Reviewed for Code Compliance
Approved by: Brandon Zipser
Permit #: 521-21-000515-STR
Date: 03/15/2022
Reviewed for Lincoln City

**LOT 2300, NE UNION AVE.
LINCOLN CITY, OR**

SITE PLAN

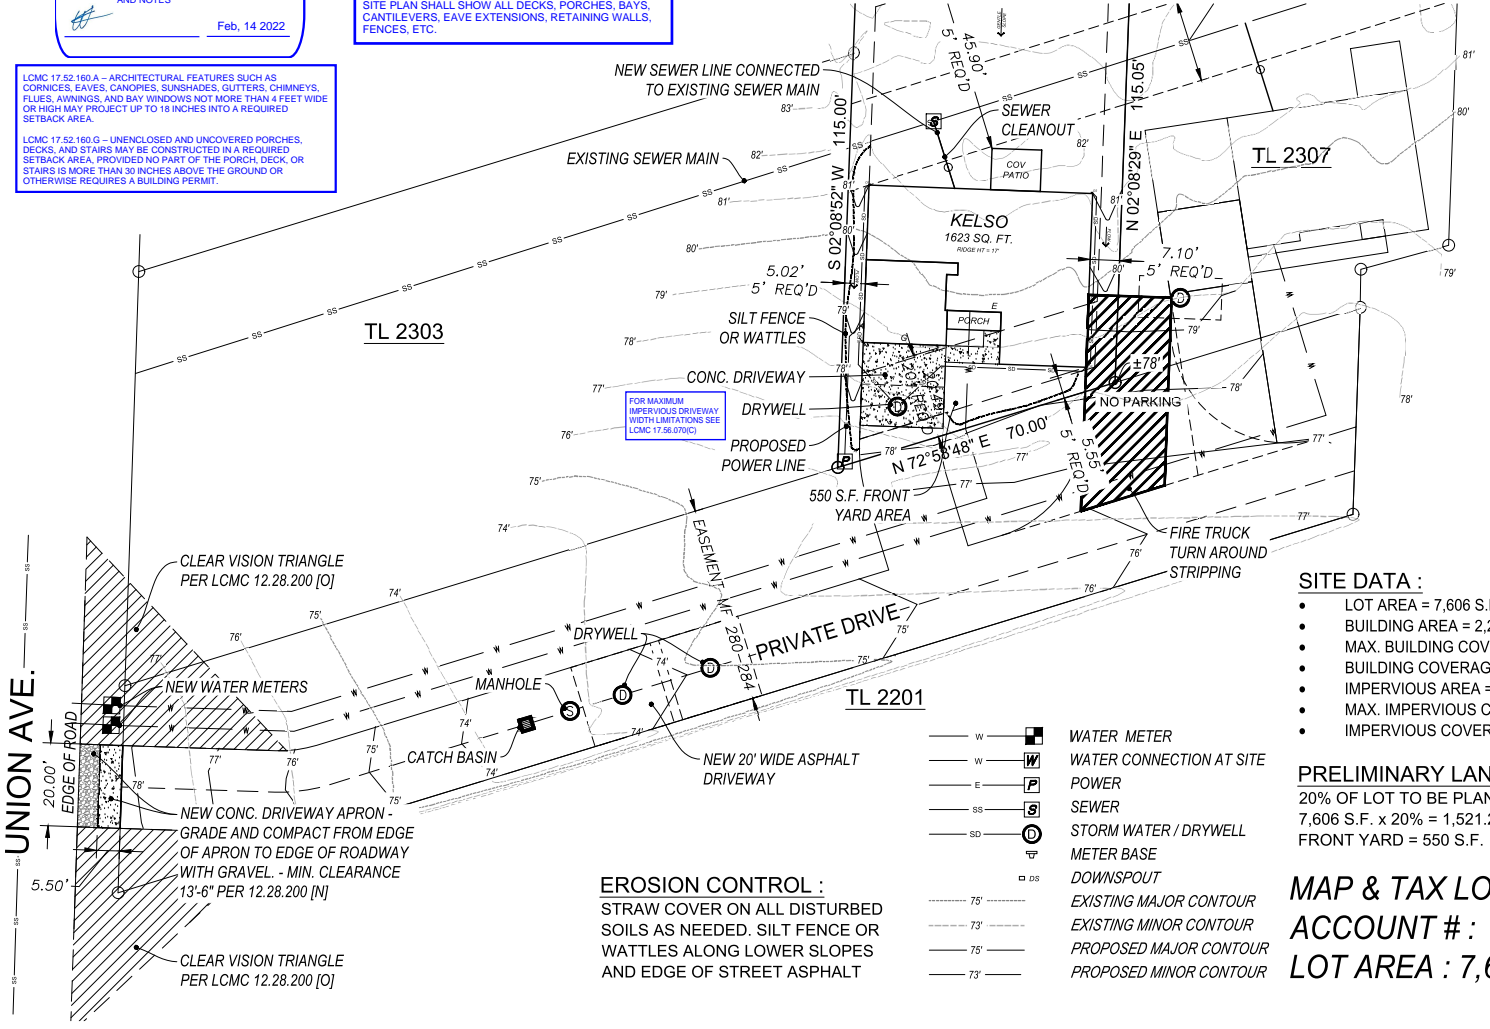
LCMC 17.52.160.A - ARCHITECTURAL FEATURES SUCH AS CORNICES, EAVES, CANOPIES, SUNSHADES, GUTTERS, CHIMNEYS, FLUES, AWNINGS, AND BAY WINDOWS NOT MORE THAN 4 FEET WIDE OR HIGH MAY PROJECT UP TO 18 INCHES INTO A REQUIRED SETBACK AREA.

LCMC 17.52.160.G - UNENCLOSED AND UNCOVERED PORCHES, DECKS, AND STAIRS MAY BE CONSTRUCTED IN A REQUIRED SETBACK AREA, PROVIDED NO PART OF THE PORCH, DECK, OR STAIRS IS MORE THAN 30 INCHES ABOVE THE GROUND OR OTHERWISE REQUIRES A BUILDING PERMIT.

PROPERTY CORNERS, PROPERTY LINES, AND SETBACK LINES SHALL BE MARKED FOR THE CITY'S FOOTING INSPECTION. THE PROPERTY OWNER IS RESPONSIBLE FOR ESTABLISHING CORRECT PROPERTY CORNERS AND PROPERTY LINES. THE PROPERTY OWNER IS RESPONSIBLE FOR MARKING CORRECT SETBACK LINES IN ACCORDANCE WITH TITLE 17.

LCMC 17.52.120.B - ALL ELECTRICAL, TELEPHONE, AND CABLE TELEVISION UTILITY SERVICE INSTALLATIONS OR CONNECTIONS MADE AS PART OF NEW CONSTRUCTION OF A BUILDING OR STRUCTURE SHALL BE PLACED UNDERGROUND.

SITE PLAN SHALL SHOW ALL DECKS, PORCHES, BAYS, CANTILEVERS, EAVE EXTENSIONS, RETAINING WALLS, FENCES, ETC.

Setbacks to property lines shall be marked at the footing inspection. The contractor of record is responsible for establishing the correct property markers and setbacks.
